Structural Remedial Schedule			
P25-0738 - 7 The Gardeners			
By : ACN	Ref : SK12	Check : MAB	Status : Preliminary
Rev : P2	Date : 13/10/2026

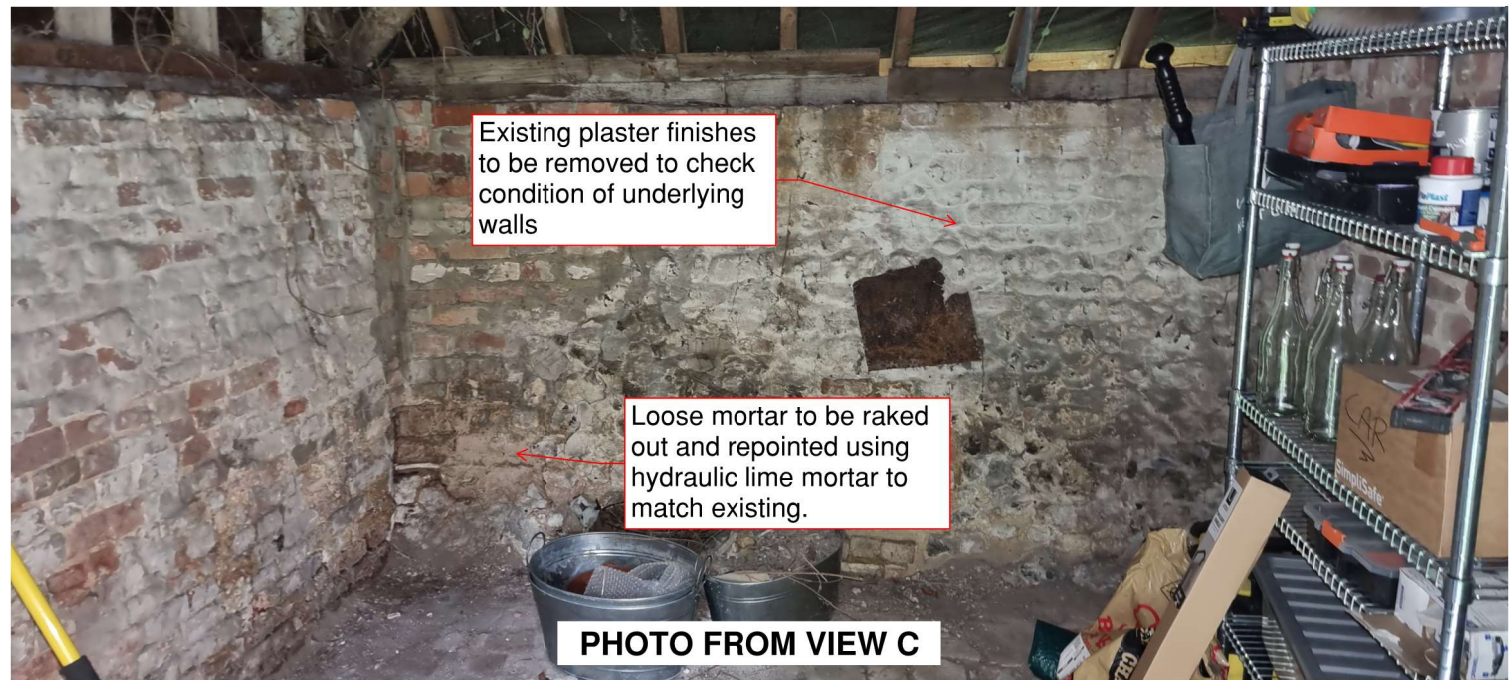
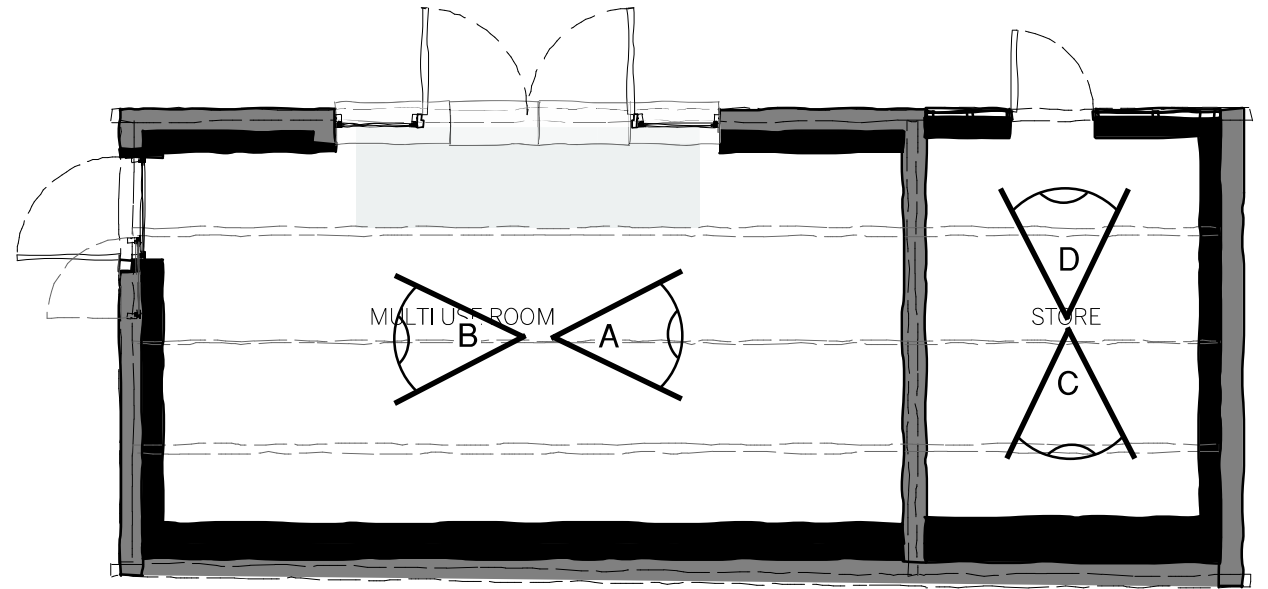
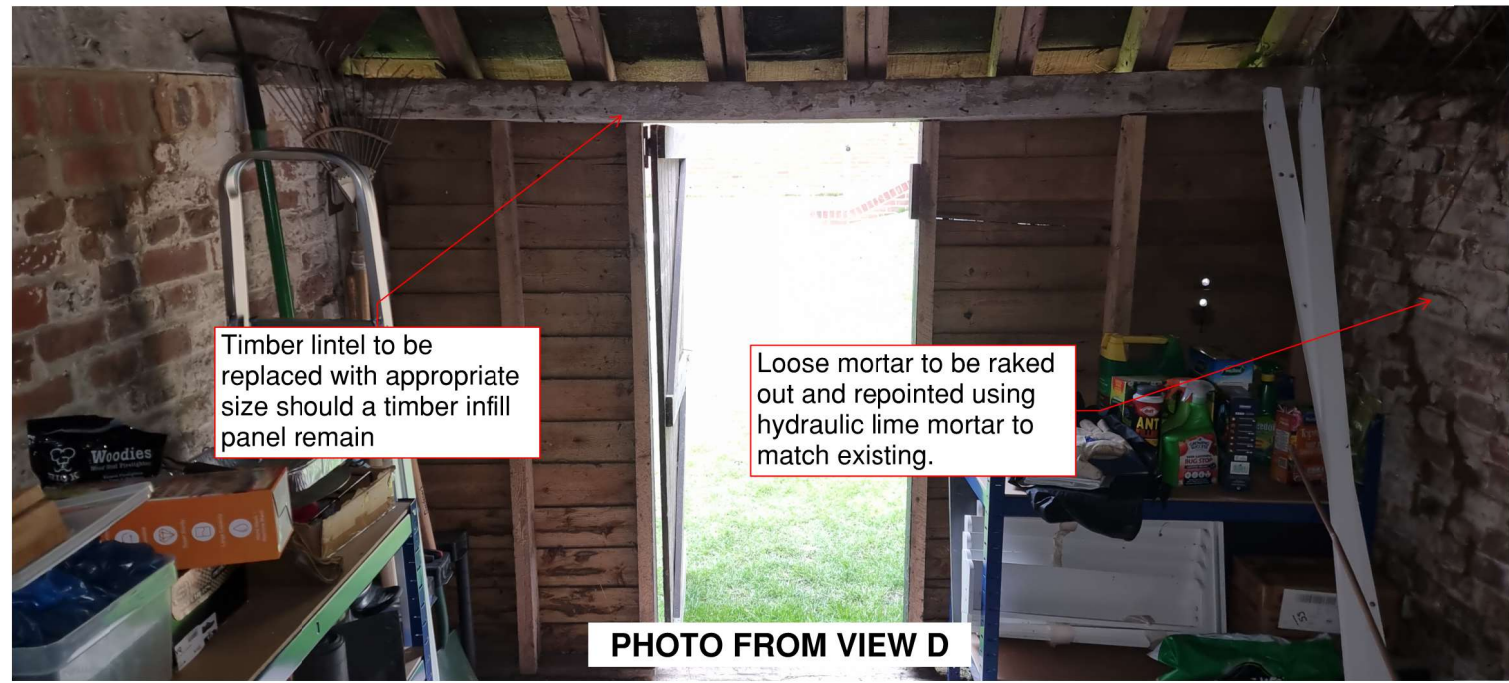
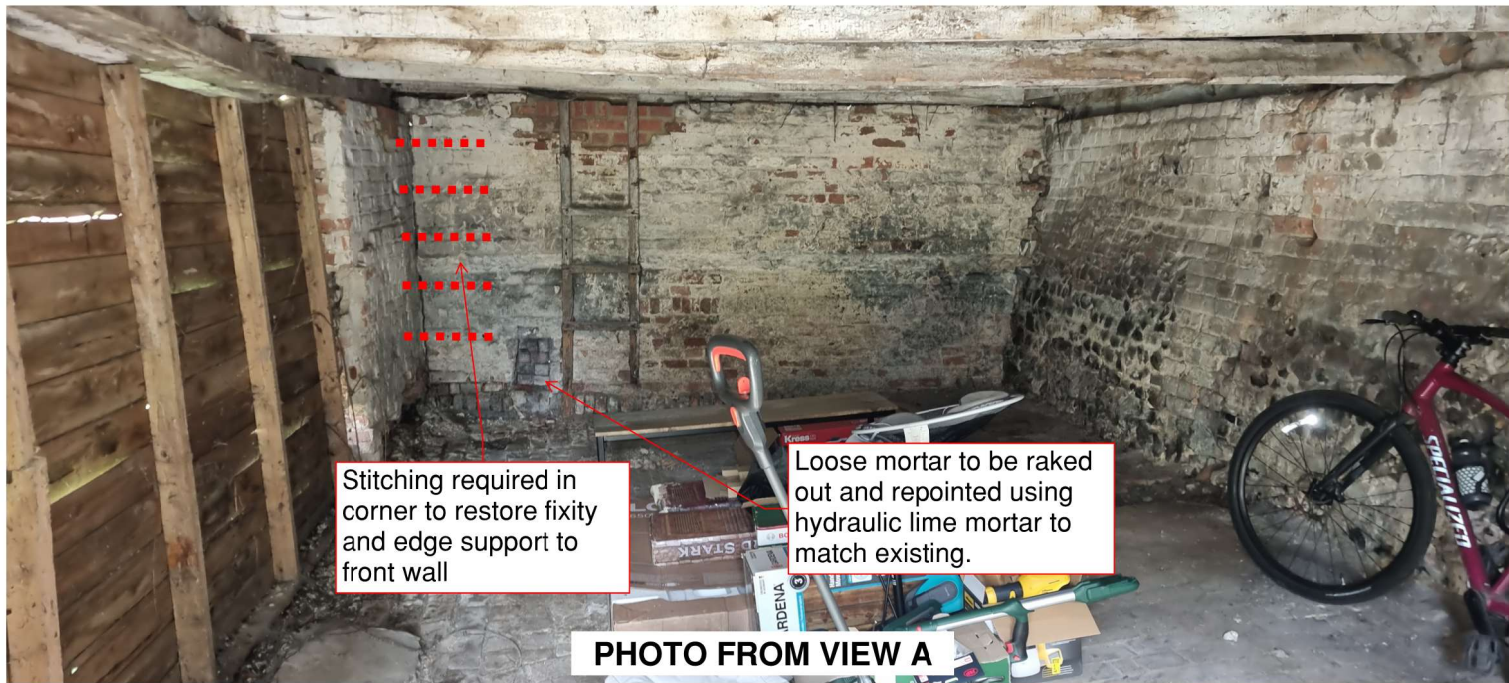
Note that repointing may be required in areas beyond what has been highlighted and that the mortar should match the existing, which has been assumed to be hydraulic lime mortar.
